FW: Development Variance Permit (DVP) Application No. E2024.011-DVP

Re: DVP Application No. E2024.011-DVP for 4535 Mill Road

Figure 6-4 Flood construction level schematic for lakes.

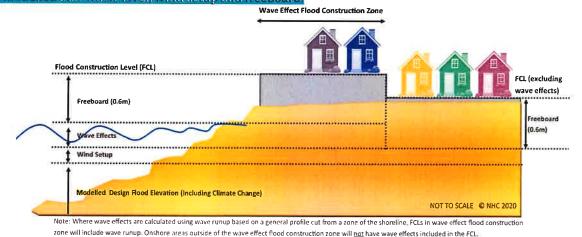
- "The maps delineate FCL extents under the design flood event... Mapping of Okanagan Lake and Wood / Kalamalka lakes is based on the flood of record (2017) adjusted to mid-century for climate change."

- "The mapped FCL includes a freeboard allowance of 0.6 metres, which has been added to the calculated flood water level to account for local variations in water level and uncertainty in the design event estimates."

- "The FCLs shown on all lake maps include an allowance for wind setup (except Ellison) and wave runup based on cooccurrence of the seasonal 200-year wind event."

- "Flooding from the lakes is identified in the mapping through characterization of two hazards lake inundation and wave effects. Lake inundation is developed through modelling of the flood elevation for each lake, called the 'still-water' level. On top of this still-water level, wind-setup (increase in water level due to the effect of the wind displacing the water in a direction due to shear), and freeboard were added. This elevation (determined for each lake) was projected on the DEM surface to identify the flood extents. The FCLs for the lake inundation zones are comprised of the modelled still-water level, wind setup and freeboard."

Okanagan Valley Zoning Bylaw 2800 Section 10.1.2(d) relies on Schedule 3 – Provincial Floodplain Maps. The data for these maps seems to date back from mid-70s to late 80s, and appear to be archaic and unrealistic.

Is there perhaps a <u>risk to RDOS for liability in negligenc</u>e when citizens and professionals continue to rely on out-dated floodplain construction levels (FCL)?
